# Access Compliance Report

## Public Rights-of-Way

Intersection ID: 45543	Main Street: GOSHAWK_LN	Cross Street: ROOK_RD	Location: NW
ADA ID: 034D4AFF476C	Ramp Type: PerpDiag	Initial Pass/Fail: Fail	Overall Compliance: No
Severity Score: 10			
Codes/Mitigation Info/Possible Solution		Field Measurements/Component Compliance

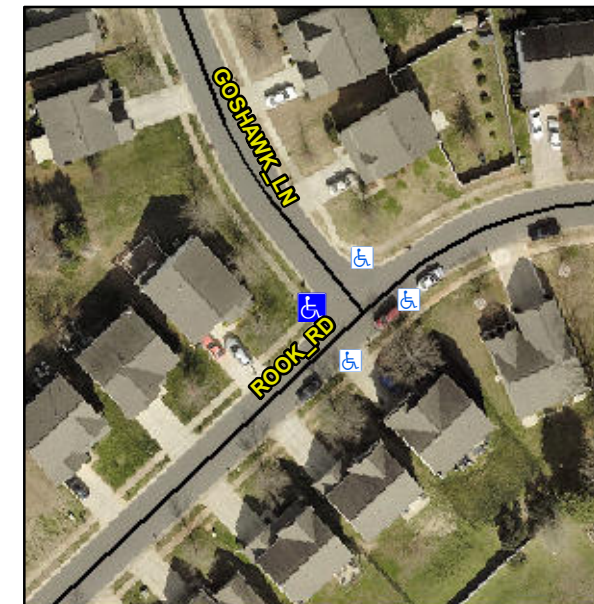
**Not Found, R304.5.1, R304.5.3**

Compliance	Description	Data	Compliance	Description	Data
N/A	Ramp Length (in)	50.0	Yes	Ramp Slope (%)	5.2
No	Ramp Width (in)	38.0	No	Ramp XSlope (%)	3.9
N/A	Flare Type LT	N/A	N/A	Flare Type RT	N/A
N/A	Flare Slope LT (%)	N/A	N/A	Flare Slope RT (%)	N/A
N/A	Flare Traversable LT?	N/A	N/A	Flare Traversable RT?	N/A
N/A	Landing Length (in)	N/A	N/A	DWS Provided?	N/A
N/A	Landing Width (in)	N/A	N/A	DWS Contrast?	N/A
N/A	Landing Slope (%)	N/A	N/A	DWS Length (in)	N/A
N/A	Landing X Slope (%)	N/A	N/A	DWS Full Width?	N/A
N/A	Landing Curb? (Y/N)	N/A	N/A	DWS Offset (in)	N/A
N/A	Shared Landing?	N/A			
N/A	Gutter Ponding?	N/A	N/A	Gutter Slope (%)	N/A
N/A	Gutter Lip Ht (in)	N/A	N/A	Gutter X Slope (%)	N/A
N/A	Painted X Walk1?	No	N/A	Painted X Walk2?	No
	X Walk 1 Direction	To SE		X Walk 2 Direction	To NE
N/A	X Walk 1 Width (in)	N/A	N/A	X Walk 2 Width (in)	N/A
	X Walk 1 Slope (%)	4.8		X Walk 2 Slope (%)	2.5
	X Walk 1 X Slope (%)	1.4		X Walk 2 X Slope (%)	5.1

**Remove & Replace Curb Ramp With Two New Directional Ramps or Equivalent.**
